Complete Streets Guidelines – Summary of the Disability, Access and Inclusion Advisory Committee October 27th 2015

Submission to Disability, Access and Inclusion Advisory Committee
Agenda Item D 15.2 – Complete Streets Guidelines

Pedestrian Safety Concerns with Proposed Complete Streets Guidelines

(1) AMBIGUOUS, CONFUSING PROTOCOL TO ENSURE PEDESTRIAN SAFETY WHEN CROSSING SIDEWALK-LEVEL BIKE TRAIL (CONTINUED)

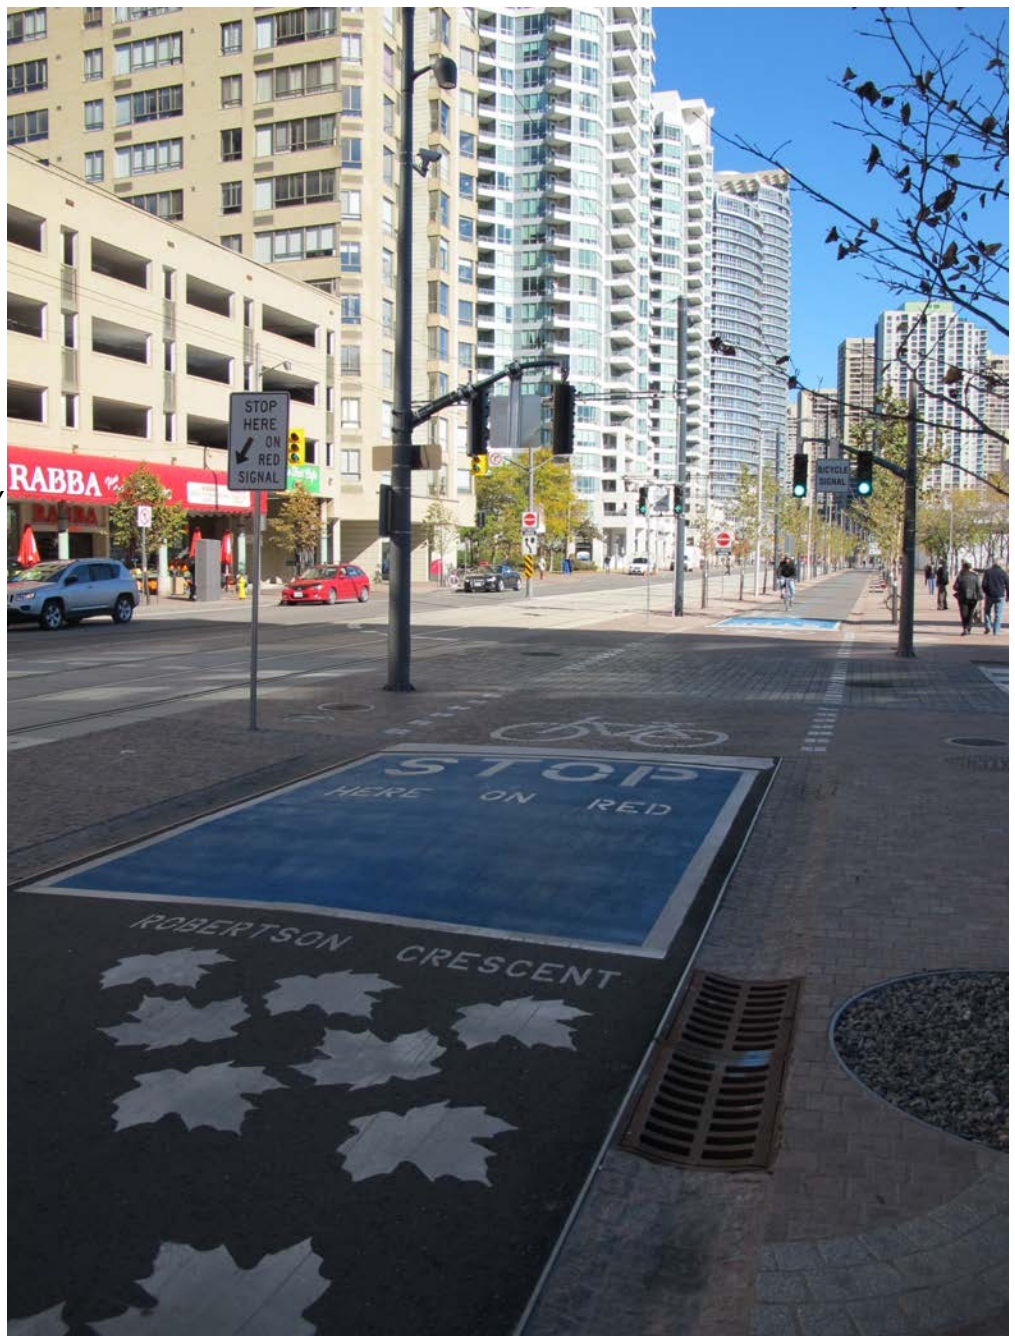
(1) AMBIGUOUS, CONFUSING PROTOCOL TO ENSURE PEDESTRIAN SAFETY WHEN CROSSING SIDEWALK-LEVEL BIKE TRAIL

Cyclists from the east are ambiguously instructed to “Watch for Pedestrians”.

What does this mean, as opposed to the clear, legal requirements to Stop or Yield?

Who has the right of way in the area between the crosswalk and south sidewalk?

Why is the crosswalk not extended to the pedestrian sidewalk area, to unambiguously ensure pedestrian safe crossing?

Cyclists from the west are give NO direction or warning when approaching the pedestrian crossing zone.

In situations with “Stop for Pedestrians” as opposed to “Watch for Pedestrians”...

Cycling lights are located far from the point of required stopping, and proper action requires clear understanding of the words “Bicycle Signal” and “Stop Here on Red”:

- *there are no requirements that foreign visitors have knowledge of English or Ontario Road Laws when renting a BikeShare bike.*
- *NYC, Barcelona and others have pictorial cycle lights at eye level, at the point of required stopping => much more direct indication of cyclist expectations.*
- *Newspaper reports indicate cyclists are routinely ignoring these “off road” stops.*

Crosswalk and walk/don't walk lights should be extended across the Bike Trail, to ensure safe passage of pedestrians to the sidewalk area.

Eye level, pictorial bicycle signals should be installed in STOP zones, to unambiguously convey this to all road users.

(2) PEDESTRIAN SAFETY RELIES ON UNREALISTIC EXPECTATIONS THAT CYCLISTS WILL SIMPLY DISMOUNT AT THE END OF THE TRAIL...

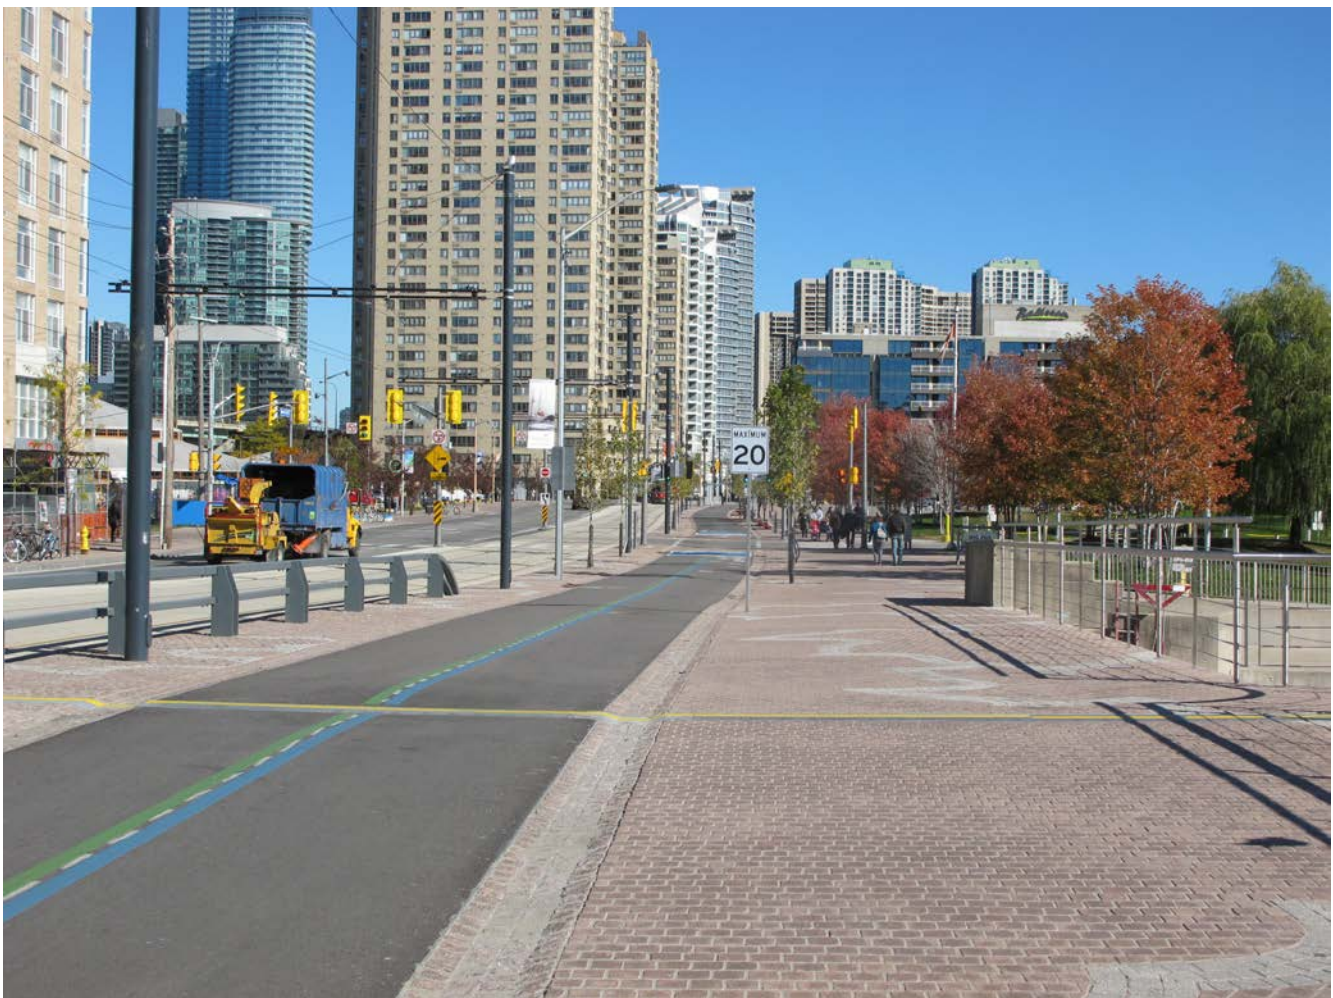
Observations noted on Saturday, October 24 were that all cyclists ignored the requirement to dismount at Dan Leckie Way.

Pedestrians are presented with signage indicating “Path Ends” as they approach the end of the crosswalk – which is meaningless. As they step onto the sidewalk, they walk directly into an unmarked area of uncontrolled sidewalk cycling.

Waterfront Toronto Staff propose to address this by adding signs that explain why this is important...which has no reasonable expectation of changing cyclist behaviour.

(4) Wellesley/Sherbourne Street TTC Stops:

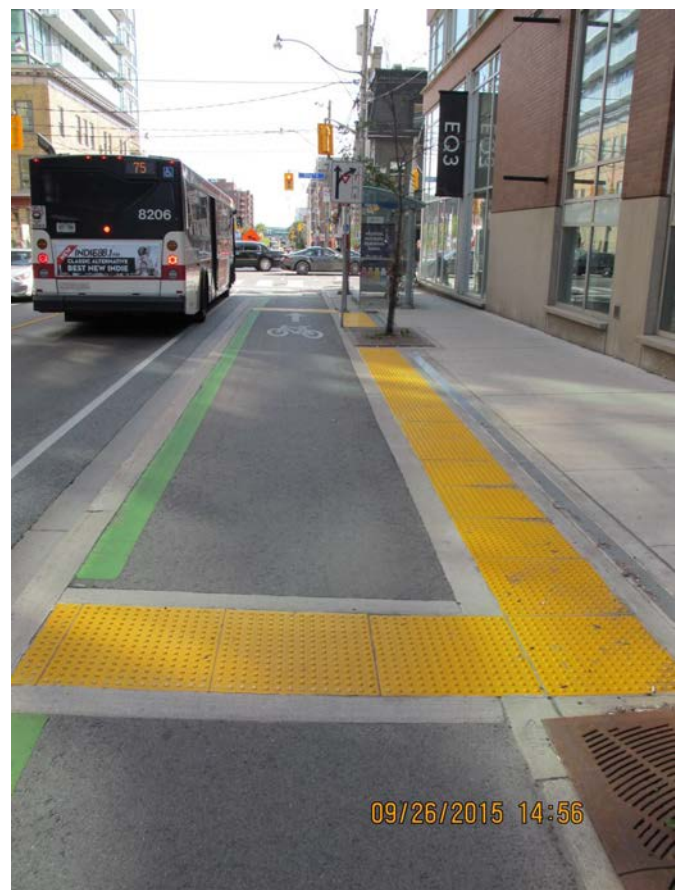
- Signage/pavement markings at these raised transit loading sites are exclusively focused on cycling priorities: “this is a bike lane”, and “cars yield to bikes, if turning”.
- Pedestrians tend to wander into bike lanes, since they are now brought to sidewalk level, endangering themselves and inconveniencing cyclists.
- *What ensures safe passage for pedestrians getting on/off buses?*
- *What discourages cyclists from sidewalk cycling around the transit shelter, to avoid the need for stopping?*

- “STOP FOR OPEN DOORS” painted on cycle track; Zebra Markings at Front/Back Door locations to signal a Crosswalk; Railings/Barriers in advance of shelter to discourage cyclists “ride-around”.
- Assess future designs with Bike Lanes between sidewalk and loading platform, with crosswalk access to get pedestrians safely from sidewalk to loading zone.
